June 24, 2024

To: Plan Holders for Improvements to the
KIRKSVILLE REGIONAL AIRPORT
KIRKSVILLE, MISSOURI
MODOT PROJECT NO. 24-028A-1

**ADDENDUM NO. 5
TO
CONTRACT DOCUMENTS, SPECIFICATIONS AND PLANS
FOR IMPROVEMENTS TO THE
KIRKSVILLE REGIONAL AIRPORT
KIRKSVILLE, MISSOURI
MODOT PROJECT NO. 24-028A-1**

A2
A-402
TICKET COUNTER SECTION
1 1/2" = 1'-0"

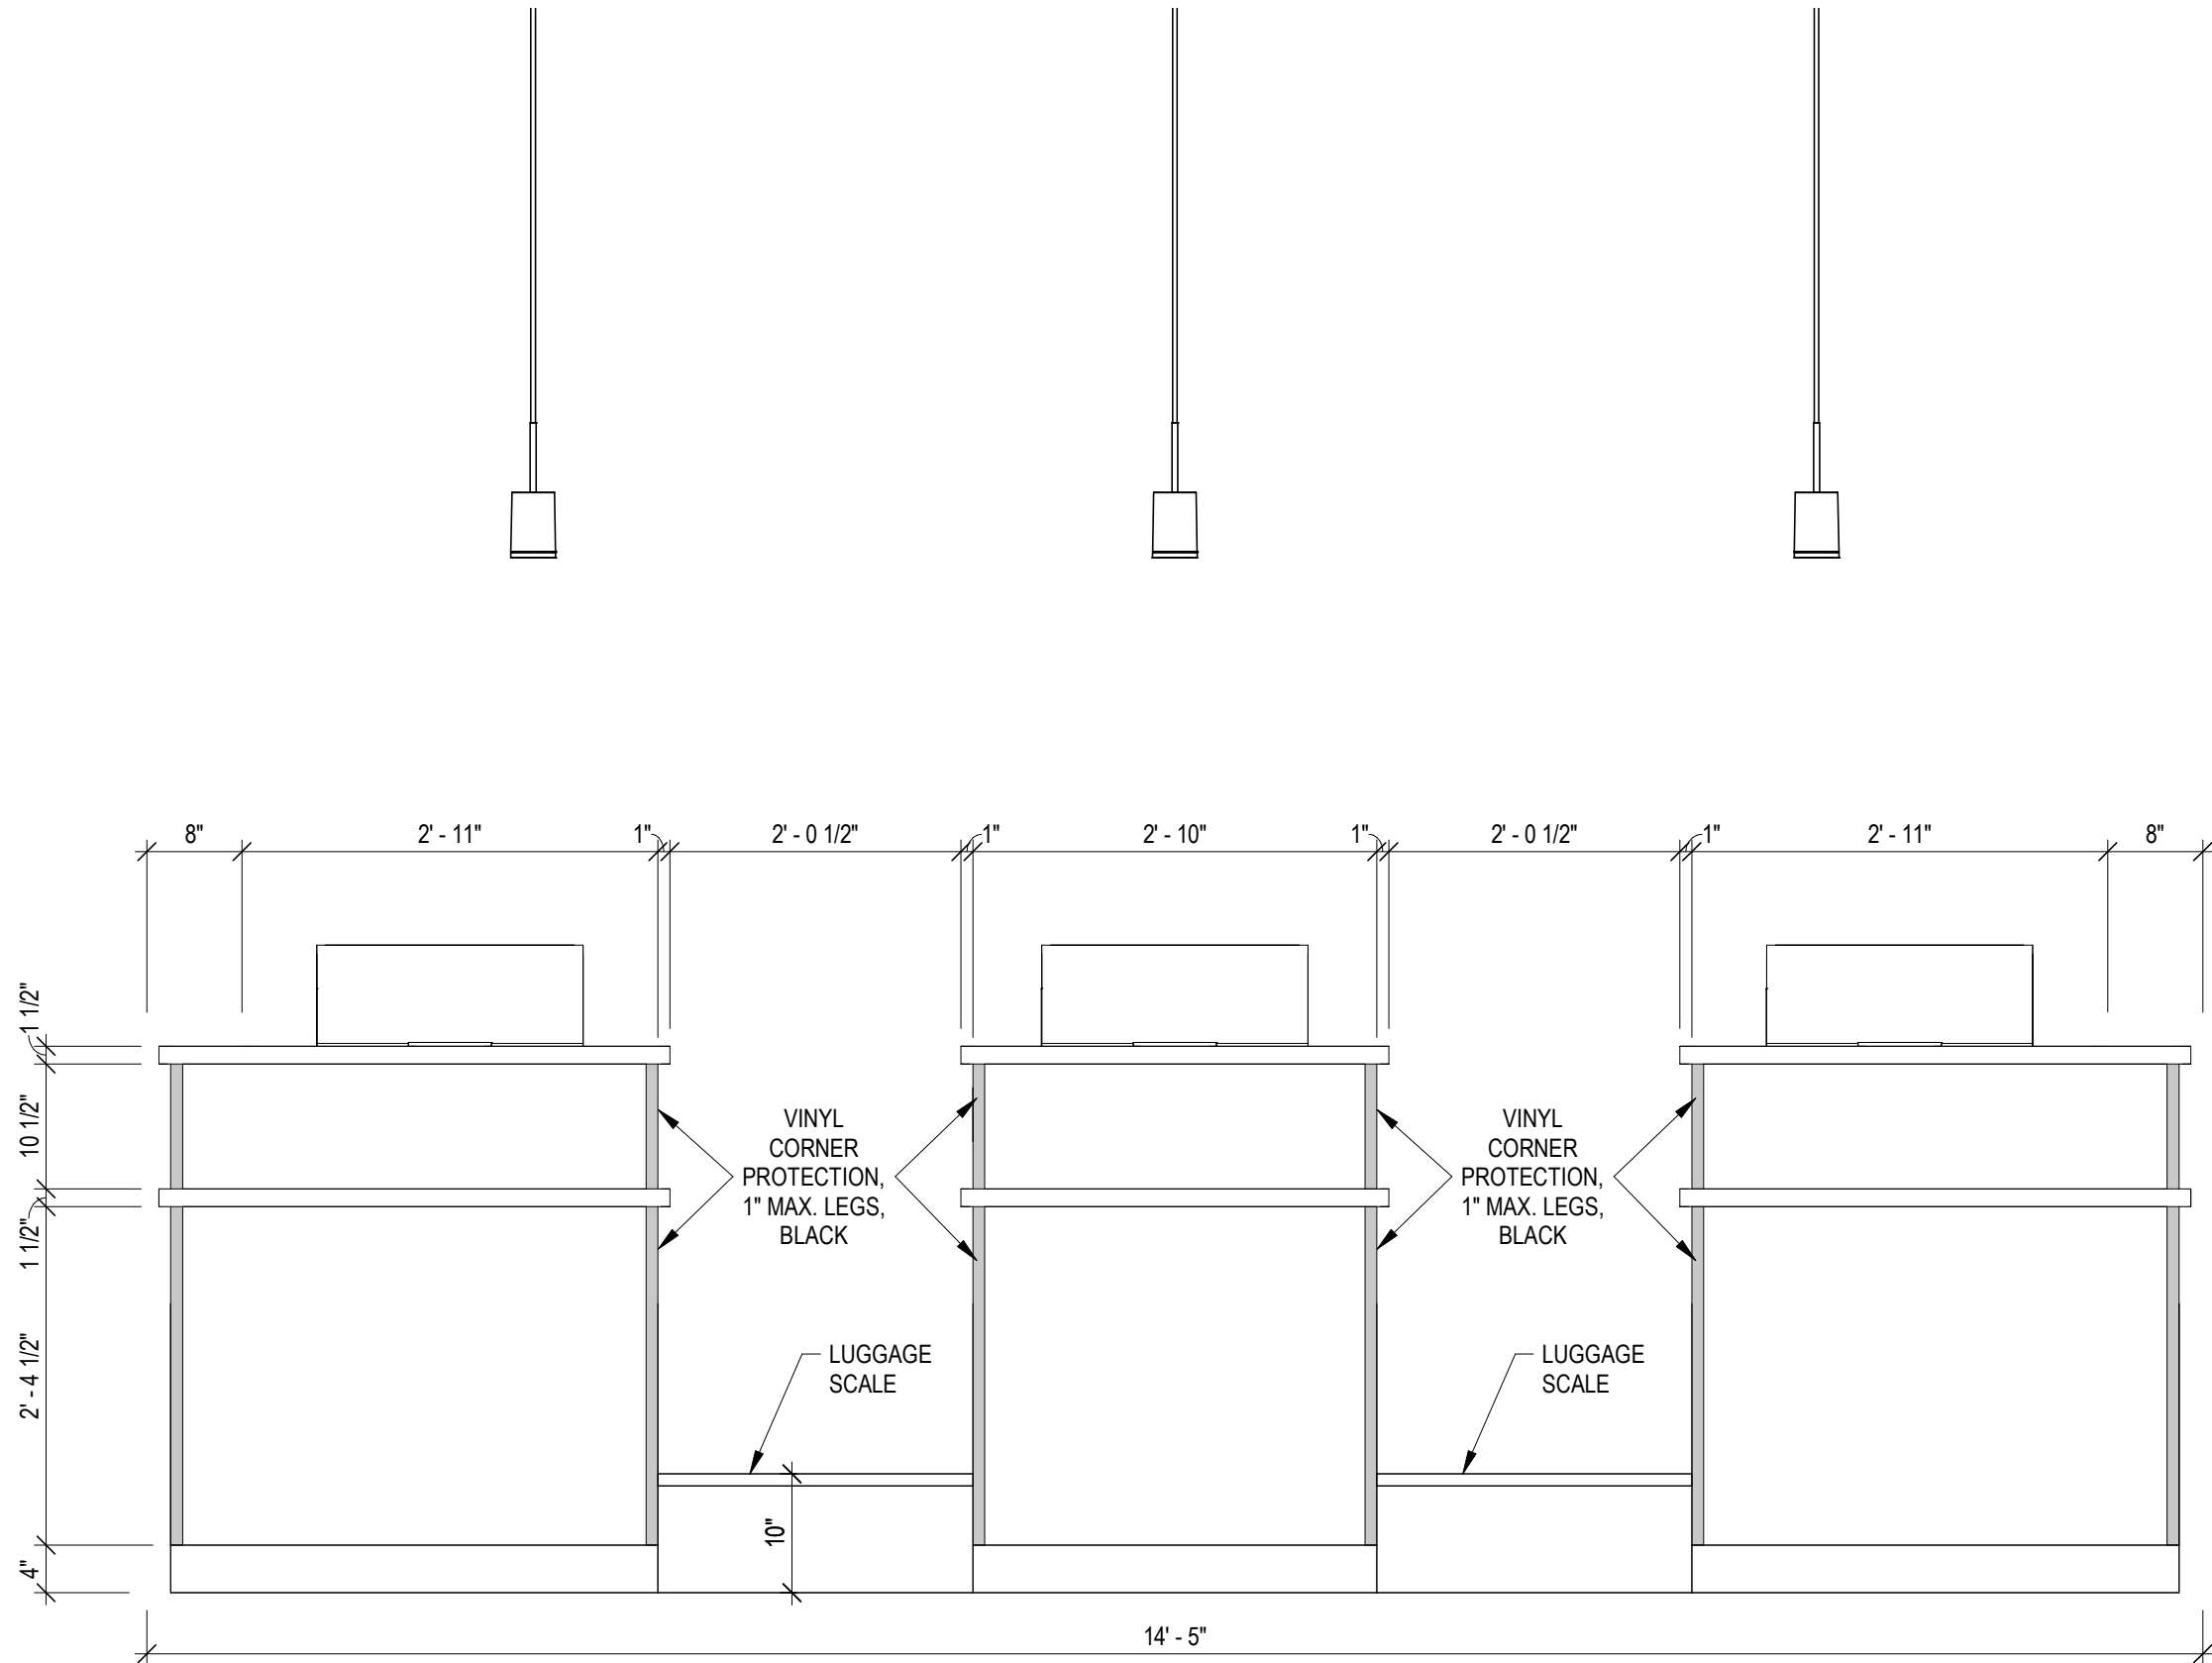
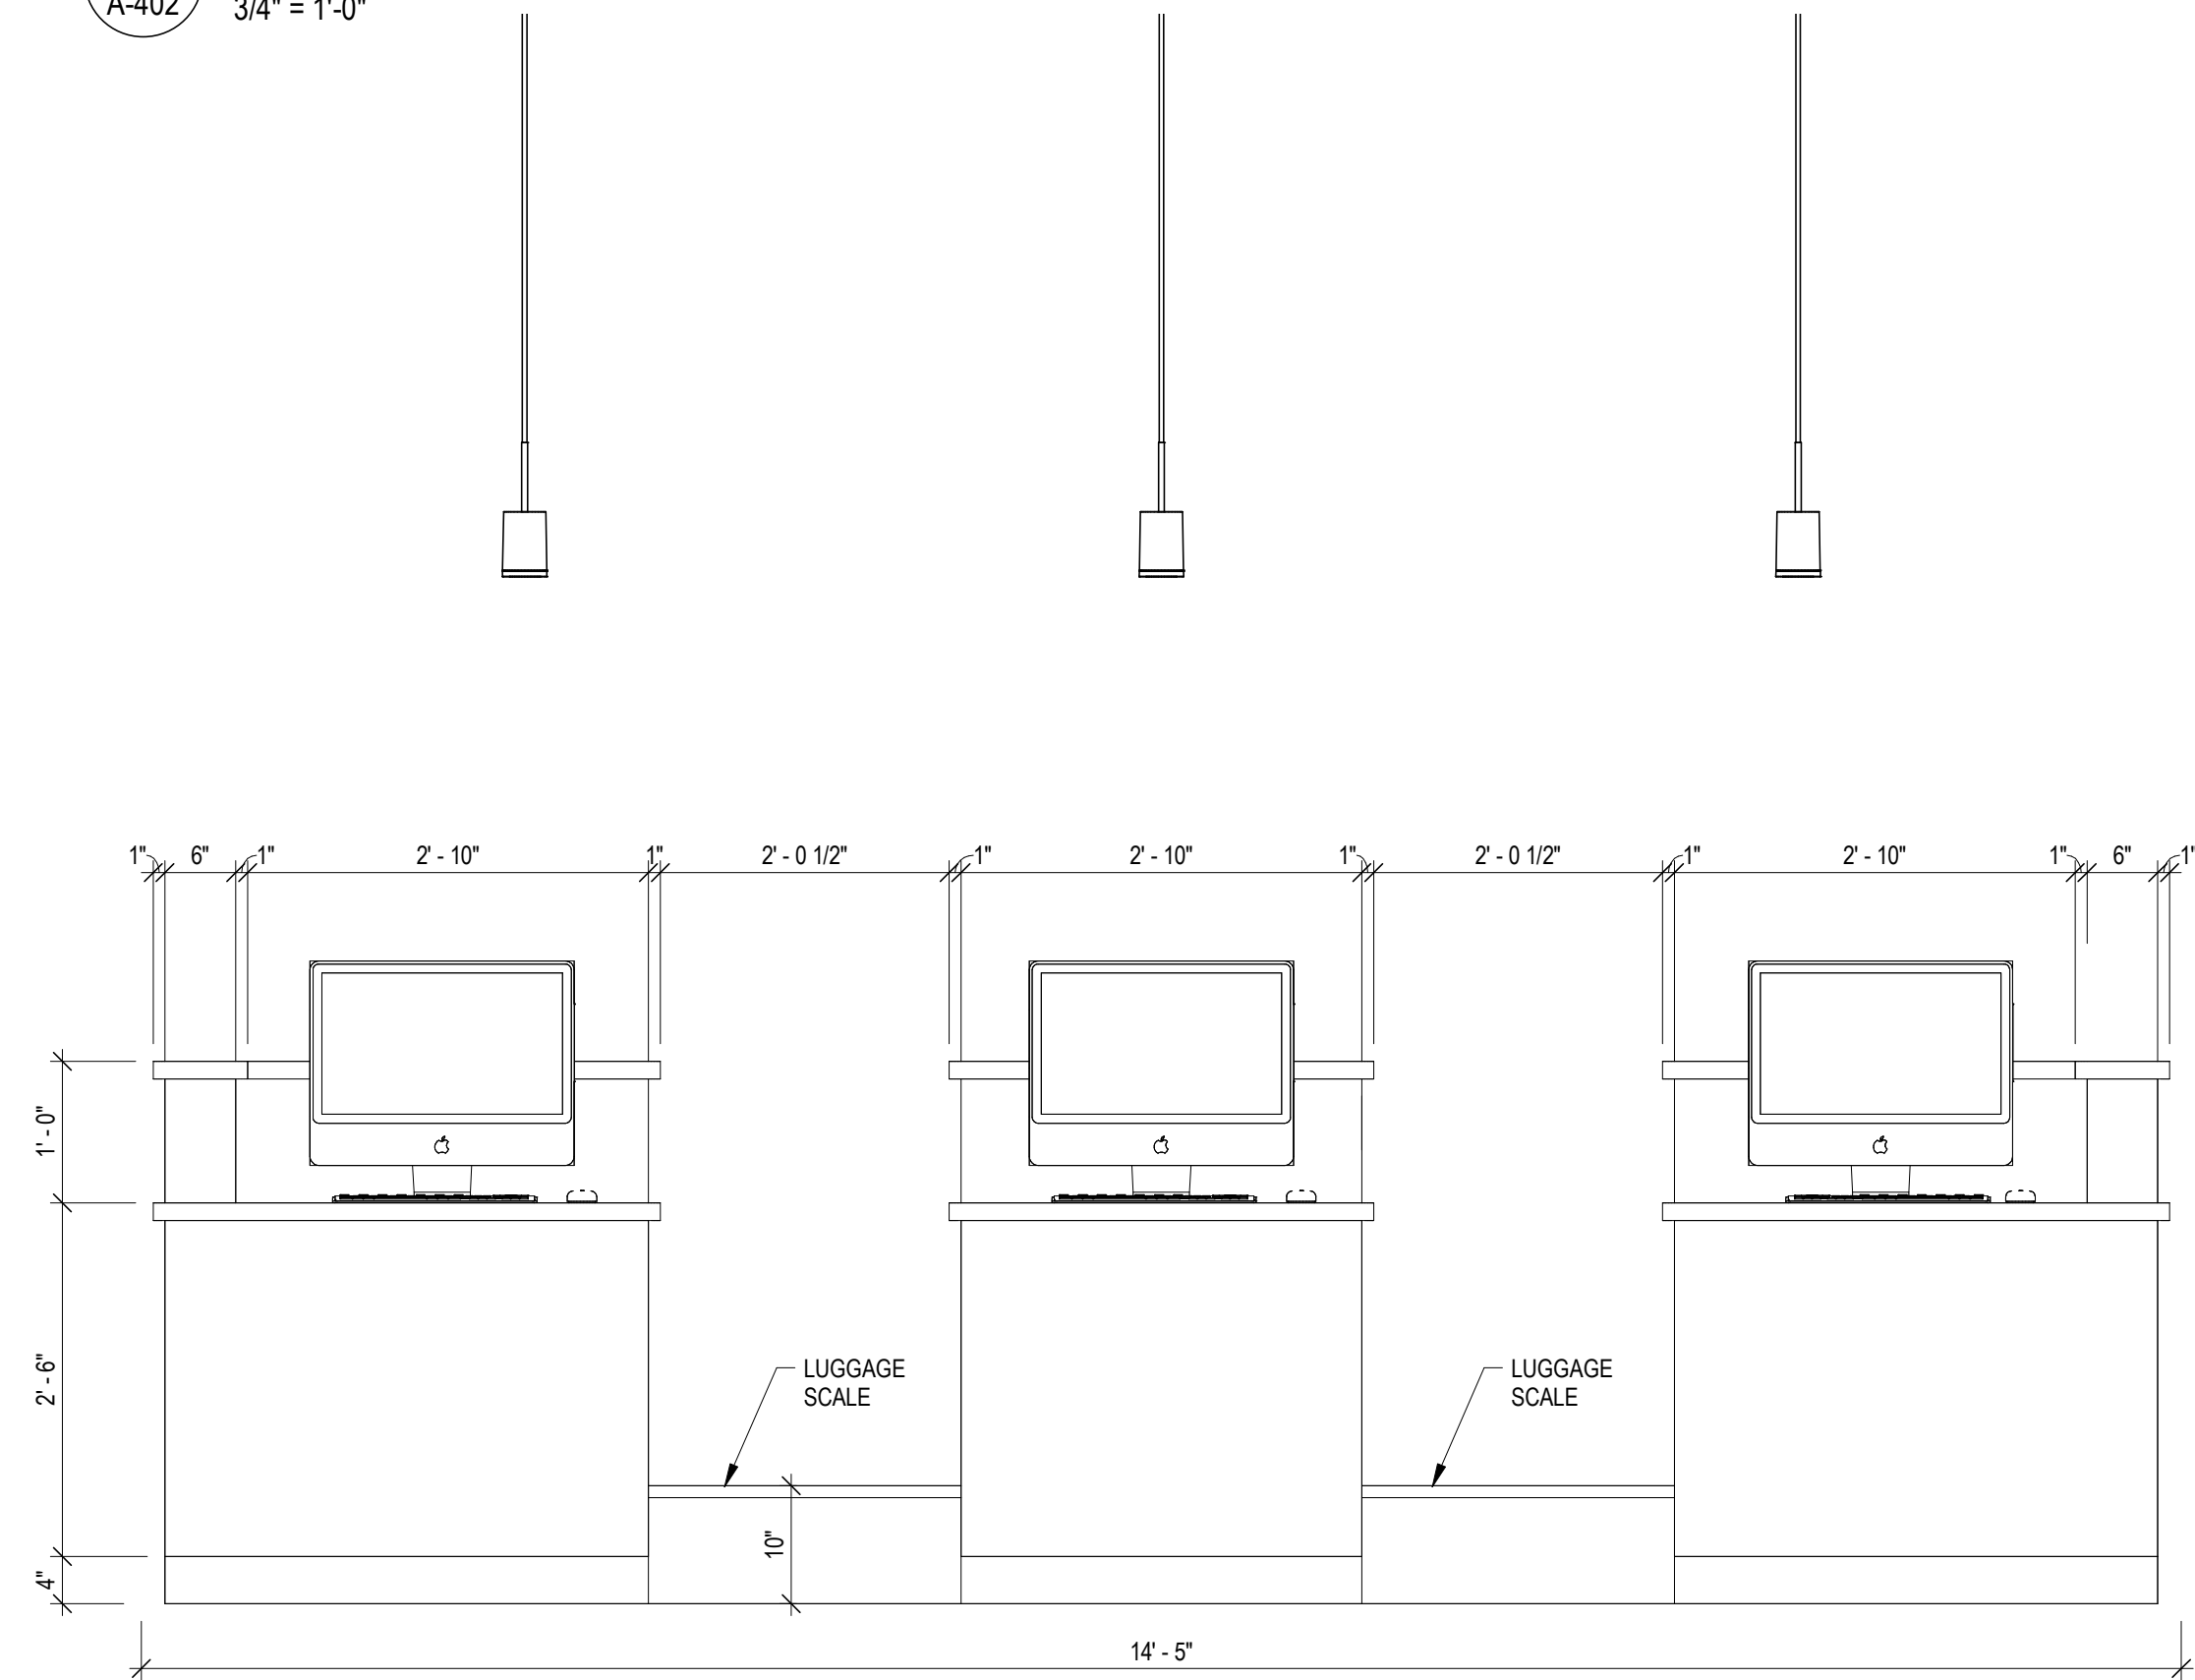
Sheet No.: A-402
Title: ENLARGED TICKETING COUNTER PLAN AND DETAILS
Revision: Ticket Counter details have been revised.
Justification: For clarity.

B3 STEEL FRAMING WRAP DETAIL
3/4" = 1'-0"

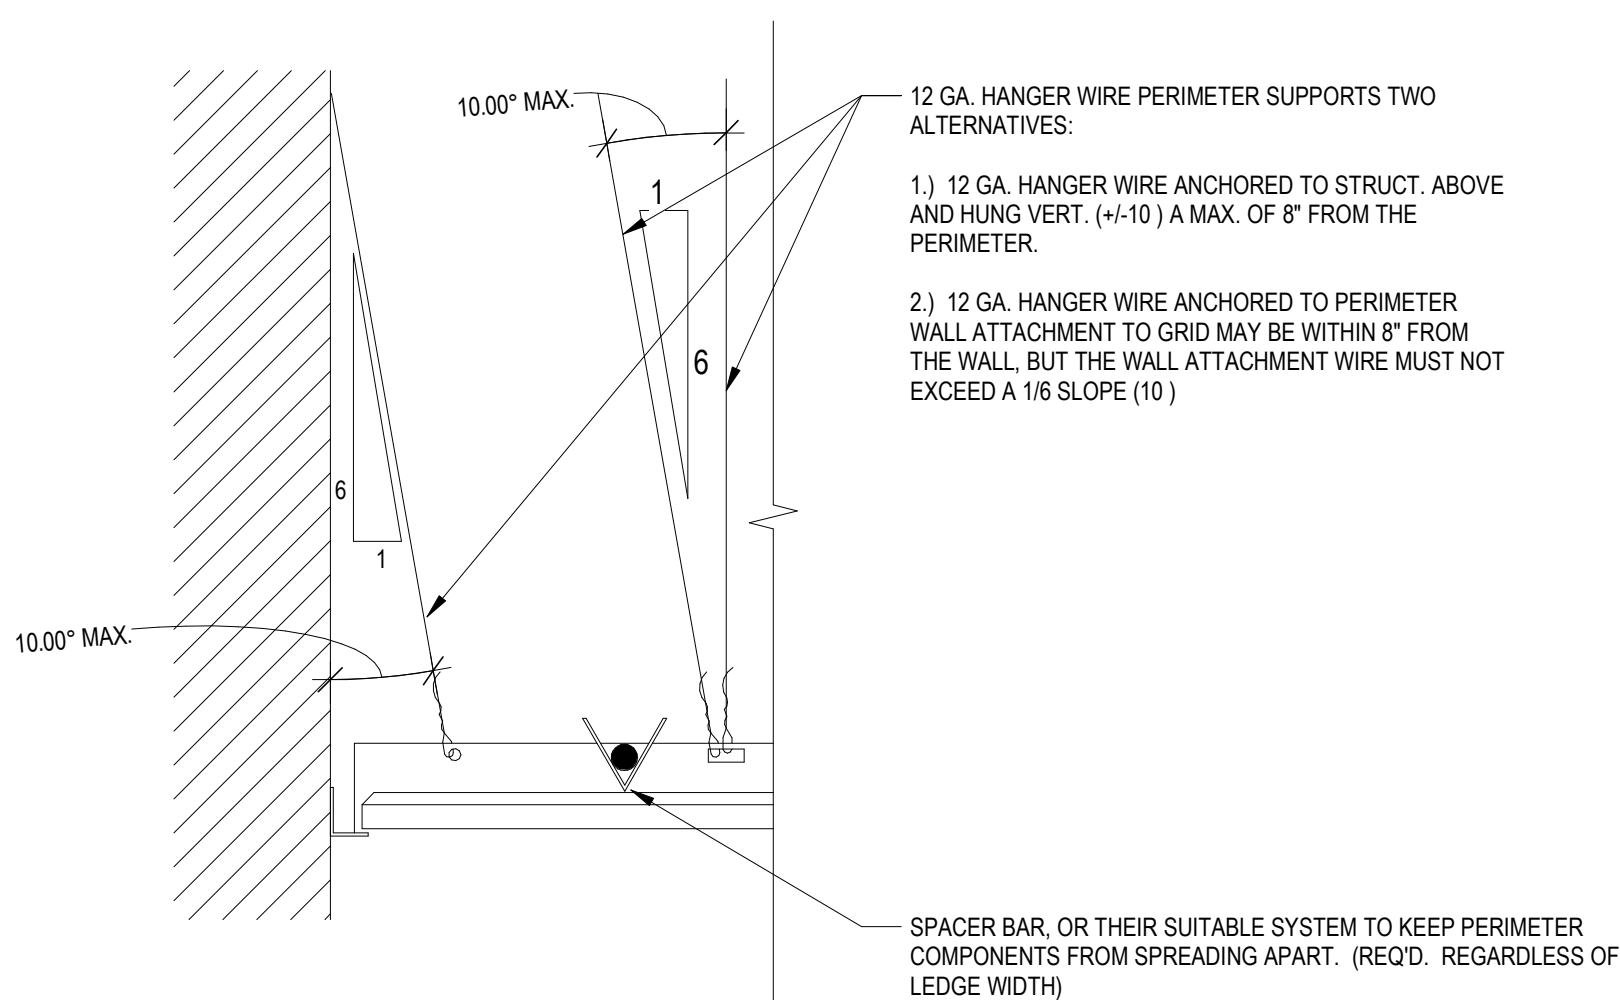
Sheet No.: A-511
Title: CEILING DETAILS
Revision: Detail B3/A-511 has been added to detail how to wrap the structural beams.
Justification: For clarity.
